CONTRACT ADDENDUM NO. 2

NOTICE TO ALL BIDDERS FOR THE:
Topeka & Shawnee County Public Library
Youth Services Renovation
HTK Project No.: 2001.01-015

Article 2-2: Drawing Sheet A201:

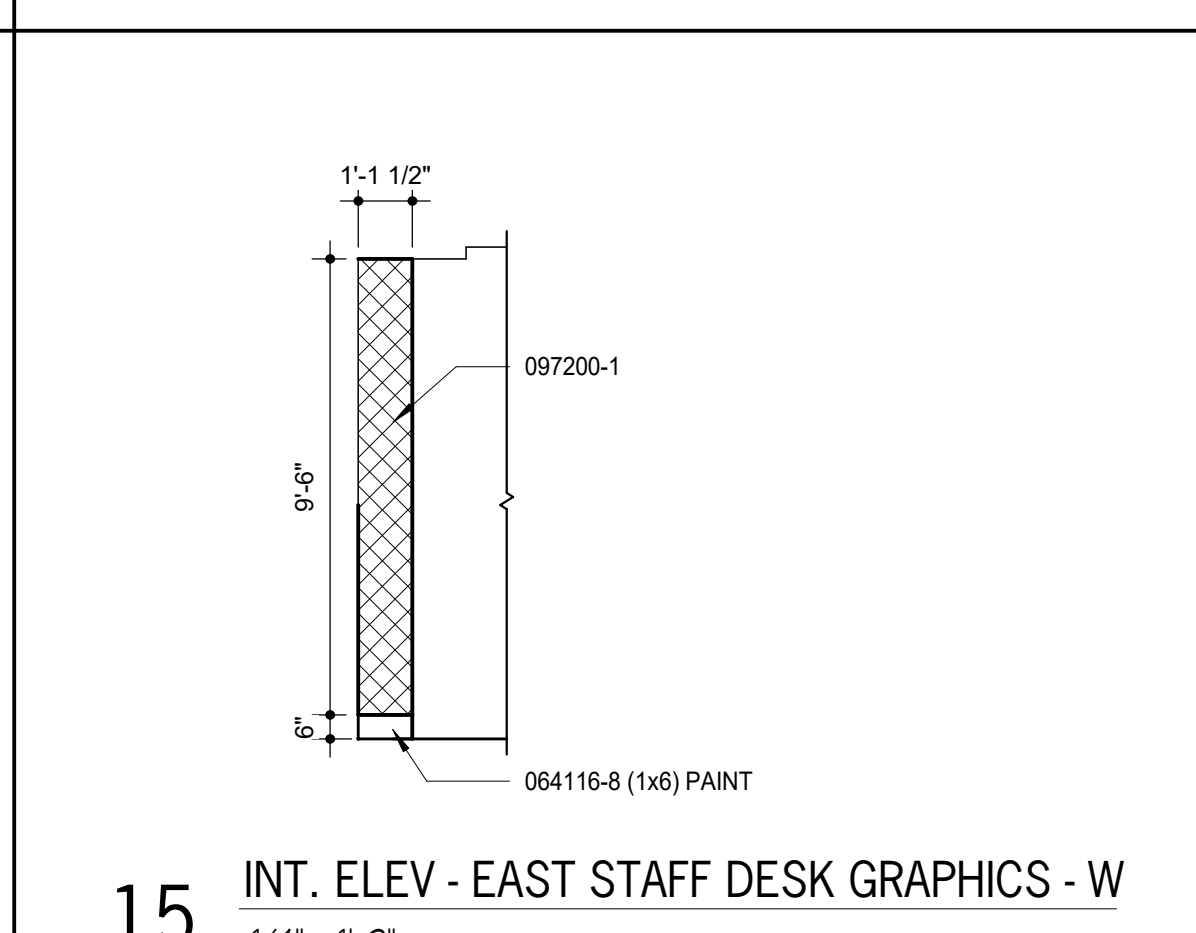
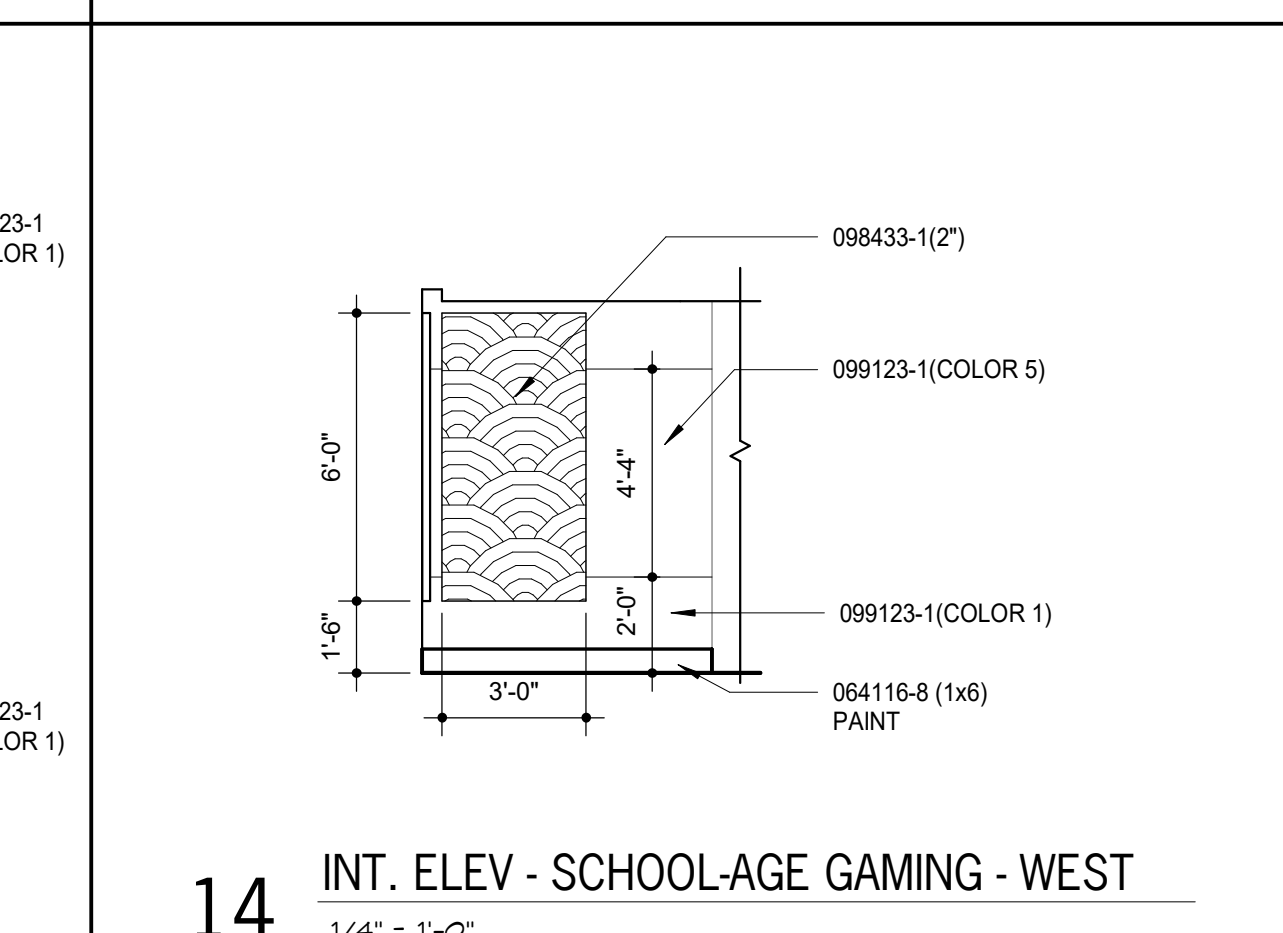
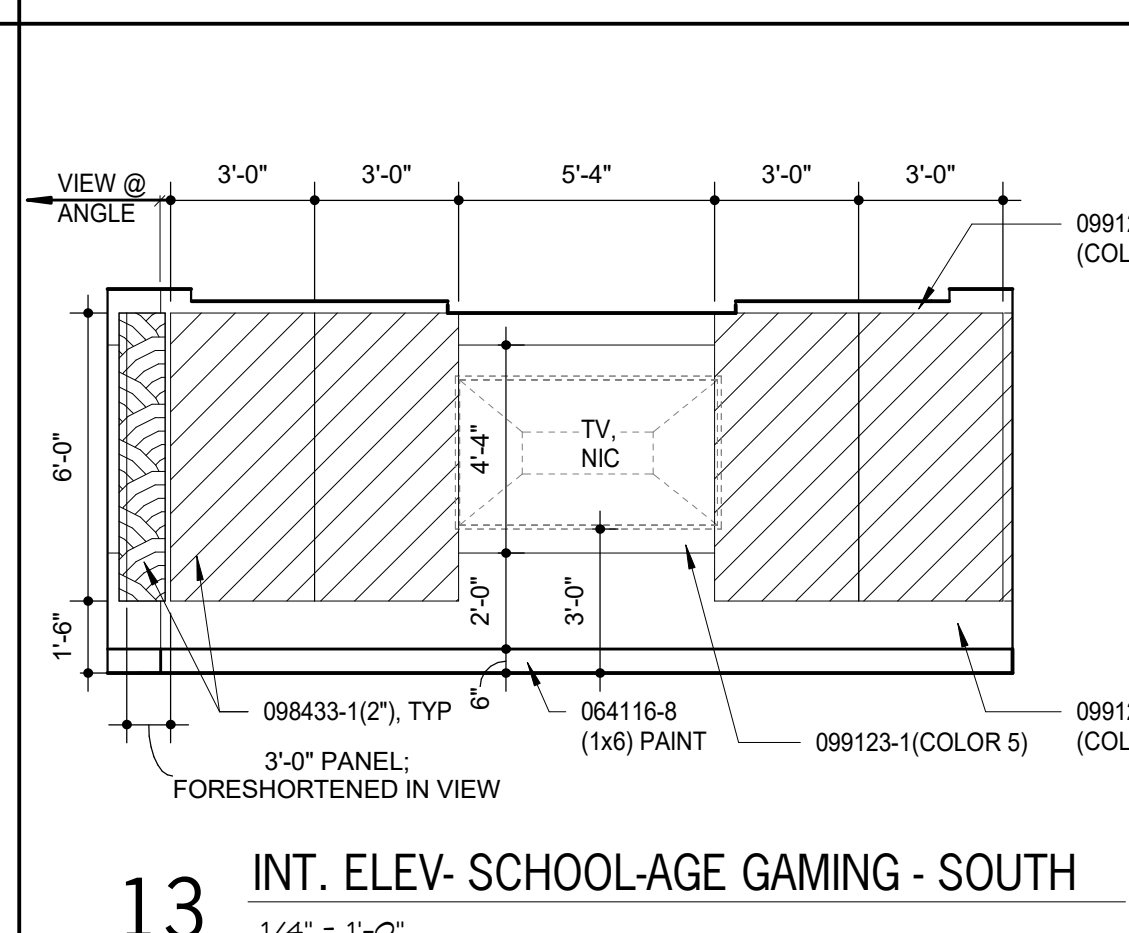
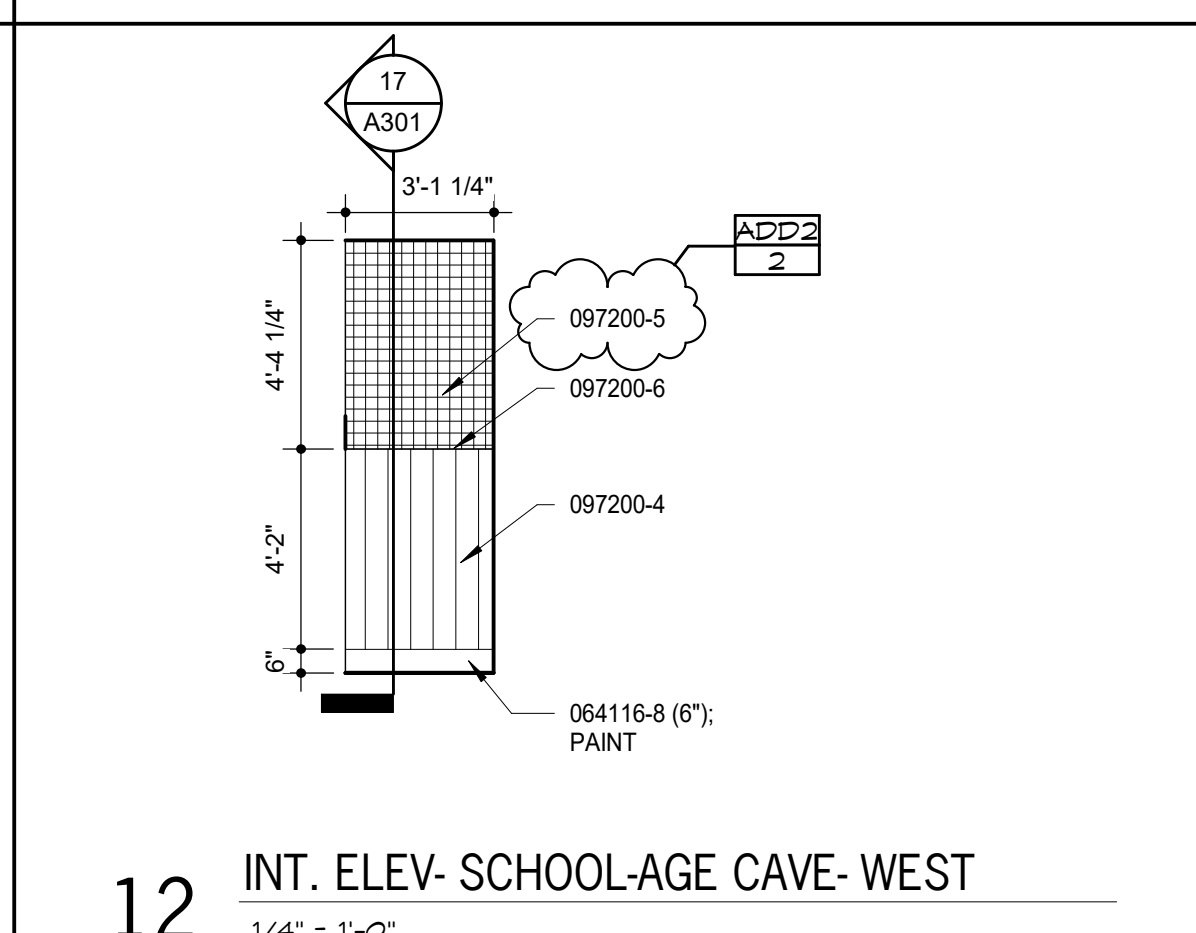
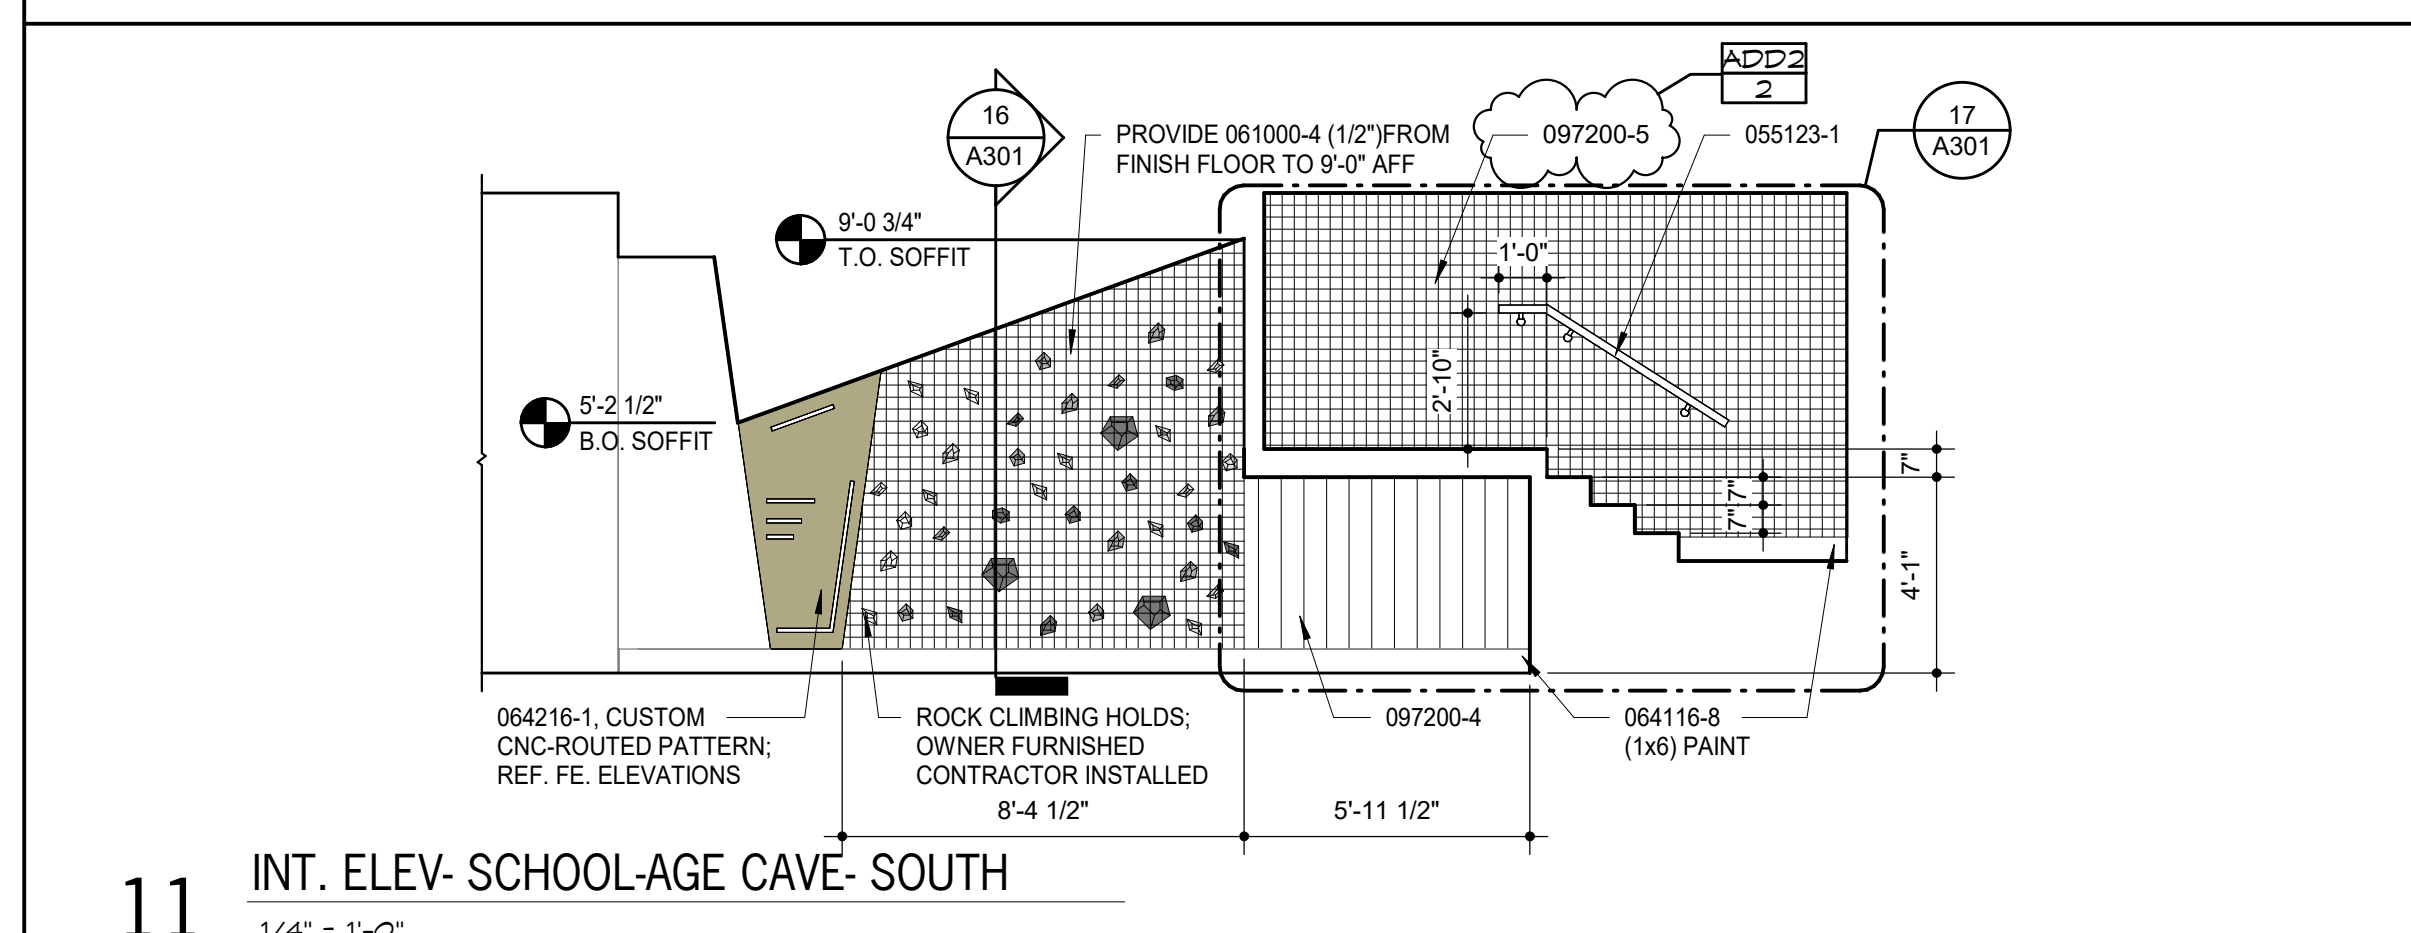
1. Revise Views 11 & 12 – Provide 097200-5 Custom Graphic Impact-Resistant Wallcovering in lieu of 097200-1 Custom Graphic Vinyl Wallcovering as shown on A201. Custom Graphic Impact-Resistant Wallcovering visible in views 7, 8, & 9. Extent of Custom Graphic Impact-Resistant Wallcovering shown in Views 11 & 12.

Article 2-3: Drawing Sheet E201:

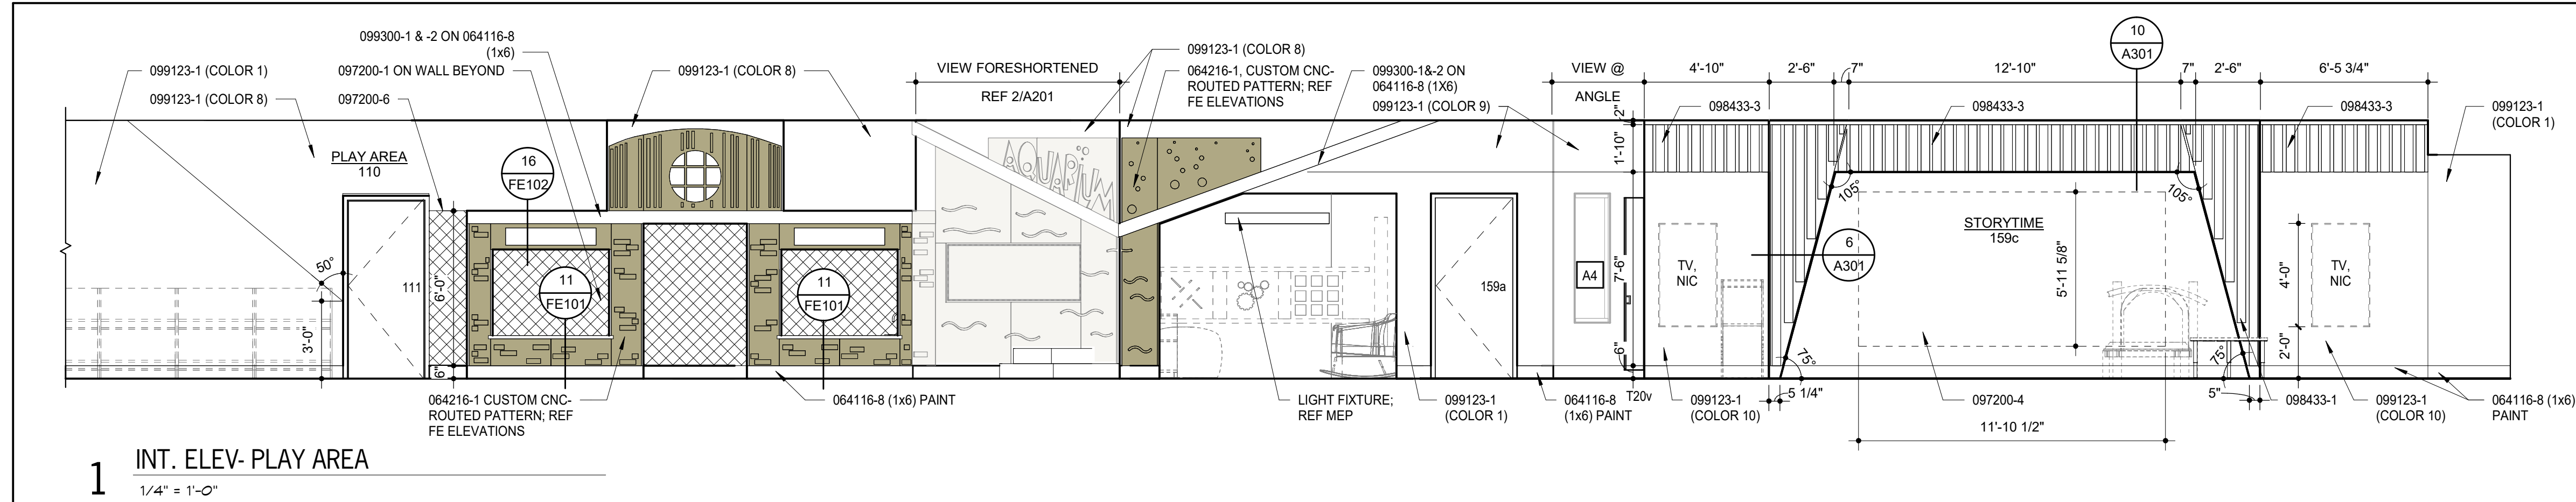
1. Clarification: Fixture Tag A1 should just be a Type A fixture connected to the emergency circuit as noted from the "2" tag.
